Subject: **COLUMBIA GENERATING STATION, DOCKET NO. 50-397
SECOND TEN-YEAR INTERVAL ISI REQUEST 2ISI-32**

10 CFR 50.55a Request Number 2ISI-32

--Inservice Inspection Impracticality—

Summary

Weld Identification N18

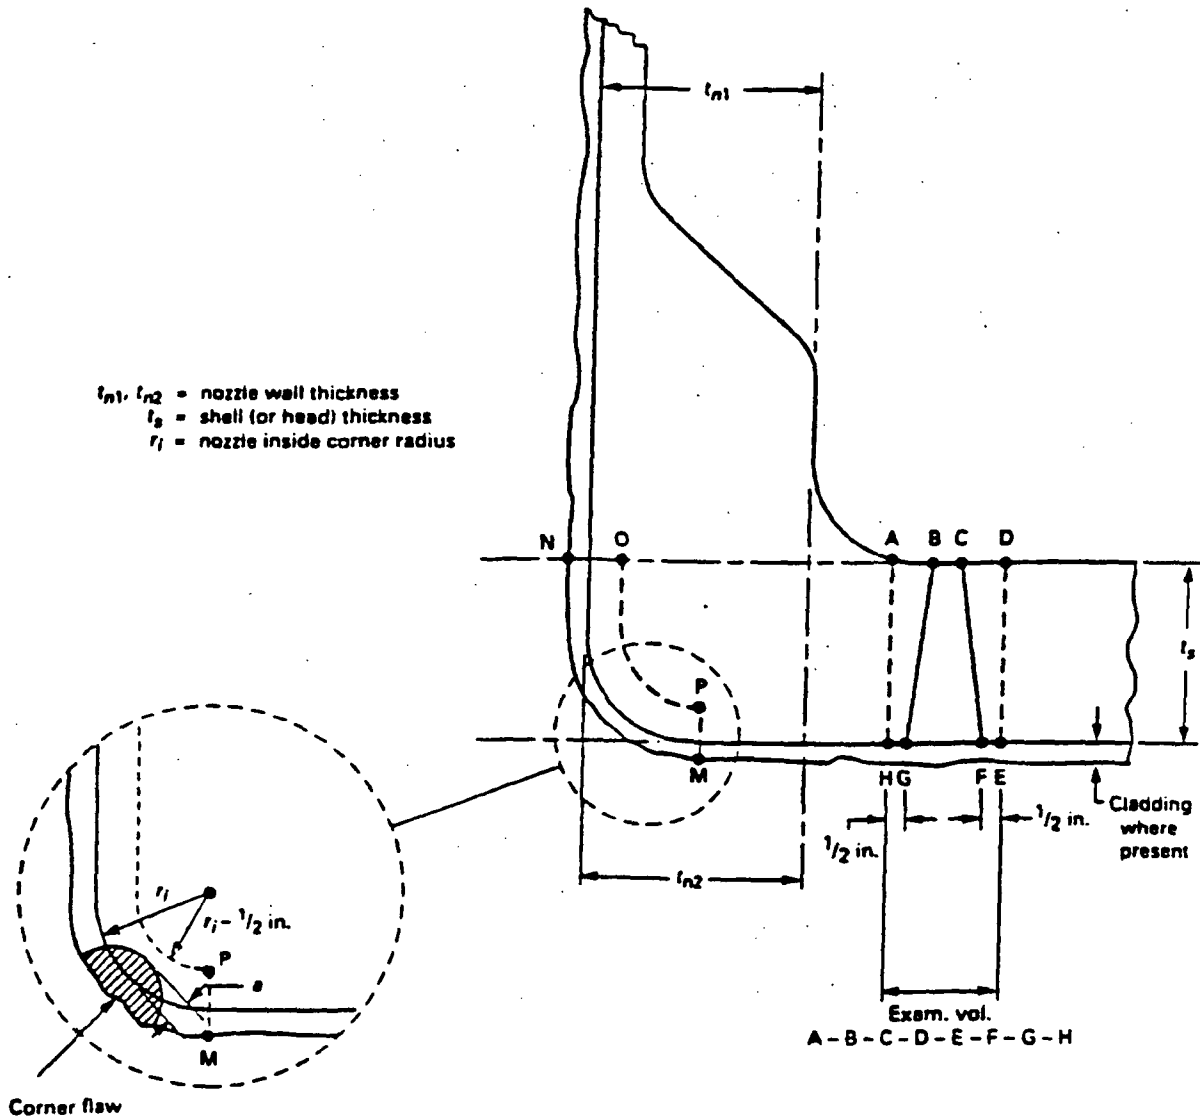
- A. Table 1 Code Category B-D weld identification N18. See additional information in attachment A. Examination requirement is per 10 CFR 50.55a request 2ISI-24, figure 2ISI-24-1. This request was authorized by letter, Nuclear Regulatory Commission to Mr. J. V. Parrish, "Columbia Generating Station - Relief Requests 2ISI-21, 2ISI-22, 2ISI-23, 2ISI-24 and Commitment Change (TAC No. MB0686)," dated April 25, 2001 (reference 1). When applying this requirement, Energy Northwest was only able to obtain 85% examination coverage of the weld due to the configuration of the nozzle. Full code examination volume was obtained in both axial directions and one circumferential direction. The other circumferential direction scan was limited by the nozzle radius configuration.

This examination was limited due to the weld Top Head to Nozzle configuration. 85.6% Code coverage was obtained.

- A. Table 1 Code Category B-D weld identification N18. The proposed alternative is to examine the weld to achieve at least 85% examination coverage. A significant volume of the weld and base material was examined to provide a reasonable assurance that any service induced flaws would be detected. The weld volume was interrogated using 0, 45, 60, and 70RL transducers. The ultrasonic technique was performed in accordance with ASME Section XI, Appendix VIII as modified by 10 CFR 50.55a and 10CFR50.55a request 2ISI-24. The examinations performed applied all the current knowledge and techniques to obtain the maximum amount of coverage to the extent practical within the limitations of design, geometry and materials of construction of the component. No indications were detected in the base material nor weld.

Weld Identification 6RCIC(1)-40

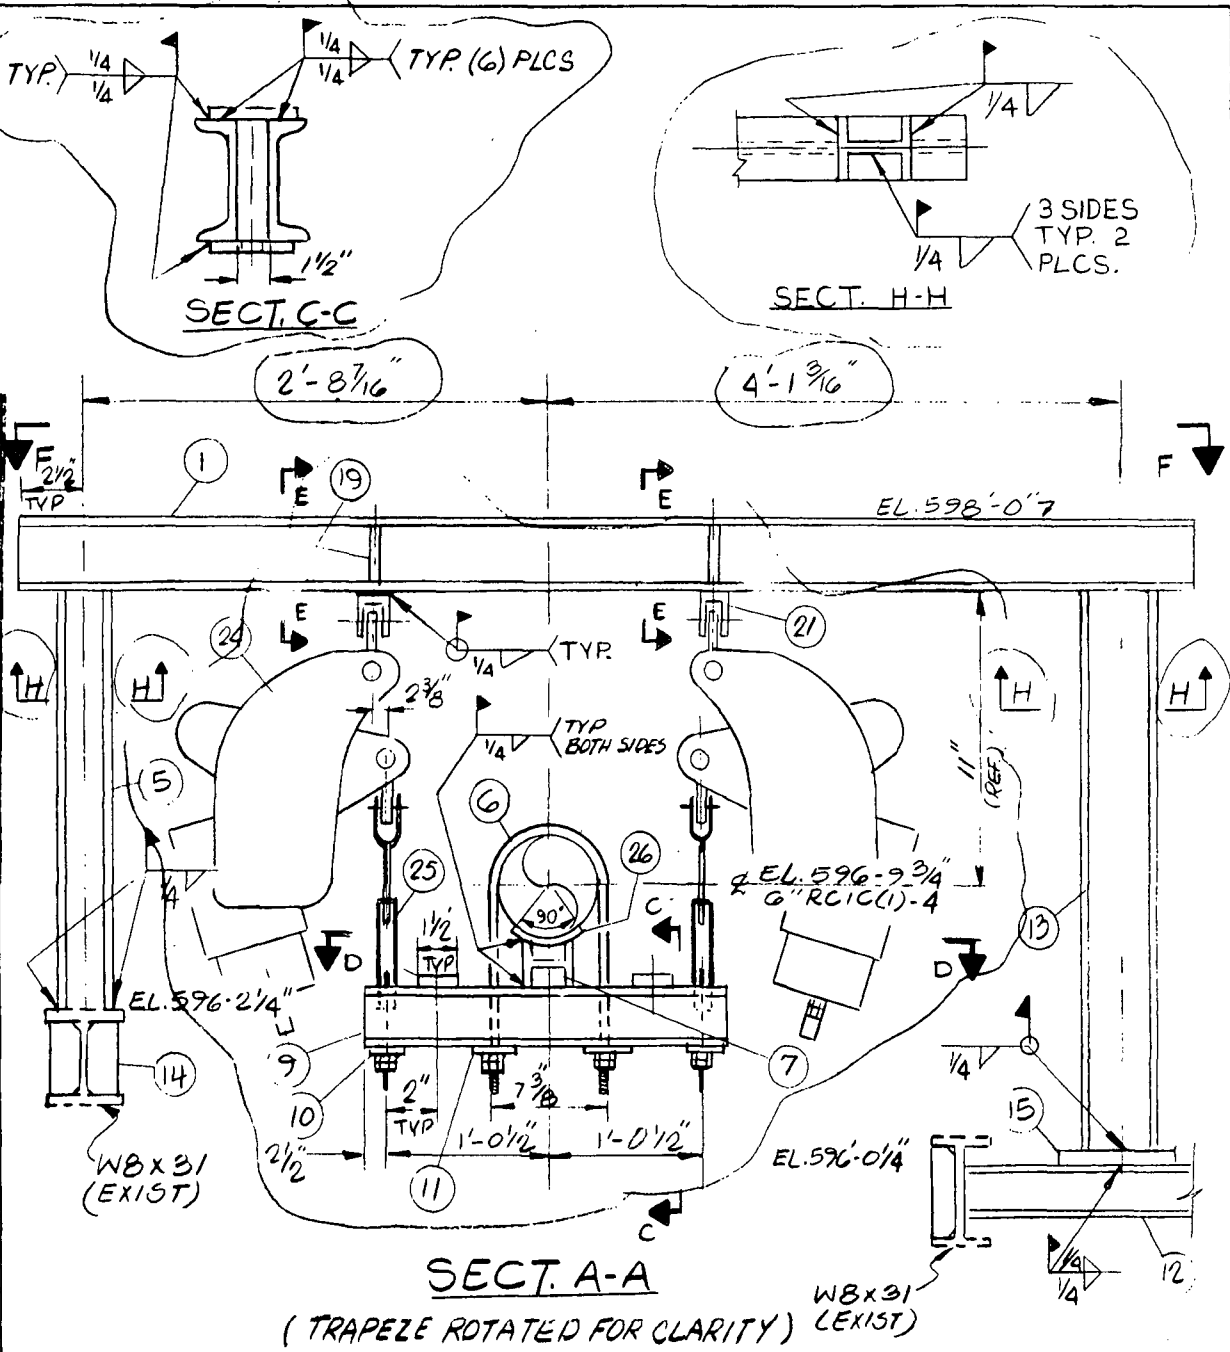
During the manual ultrasonic examination of the above referenced weld, no reportable indications were recorded utilizing the 45° and 60° search units. Root geometry was recorded by the 60° search unit.
